Subject: MHI's Responses to US-APWR DCD RAI No. 894-6270 Revision 3 (SRP 03.08.03)

Response to Request for Additional Information No. 894-6270,
Revision 3

**US-APWR Design Certification
Mitsubishi Heavy Industries
Docket No. 52-021**

RAI NO.: **NO. 894-6270 REVISION 3**
SRP SECTION: **03.08.03 – Concrete and Steel Internal Structures of Steel or Concrete Containments**
APPLICATION SECTION: **3.8.3**
DATE OF RAI ISSUE: **1/25/2012**

Figure 1. Damping ratios of SC and RC walls (Kim et al. 2009)

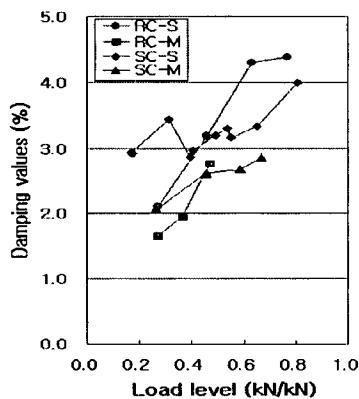
The Executive Summary of MHI Technical Report MUAP-11018-P (R0), first table on page viii, indicates that the damping ratios of SC Category 1 walls under loading condition A and B are 4% and 5%, respectively. According to the report, the 5% damping ratio is based on test results of the 1/10th scale test. Since the 1/10th scale test is for the entire CIS structure which includes various SC category types, not just the SC Category 1 walls, the staff requests that the applicant provide additional justification/test data to justify the use of the 4% and 5% damping ratios for the SC Category 1 walls used in the US-APWR Containment Internal Structure (CIS).

In addition to the evaluation of SC damping in the 1/10th scale experiment, the relative damping ratios of SC and RC structures have been investigated experimentally by Kim et al.¹ Kim et al. conducted free vibration tests of equivalent SC and RC wall specimens to compare their relative damping values. The damping values were determined using experimental measurements and the logarithmic decrement method. Figure 1, which is extracted from Kim et al. summarizes the key experimental data from the tests. In this figure, RC-S and SC-S are squat shear walls governed by shear behavior, and RC-M and SC-M are taller walls governed by flexure behavior.

As shown in Figure 1, increasing loading results in more damping due to concrete cracking. The damping ratios for SC are slightly lower than those of equivalent RC systems. It is important to note that the experimental damping values for both SC and RC systems are anticipated to be lower than in an actual structure, because the tests involved isolated structures with no non-structural attachments, equipment, or piping, and the specimens were subjected to free vibration from various starting points associated with different levels of loading (and cracking).
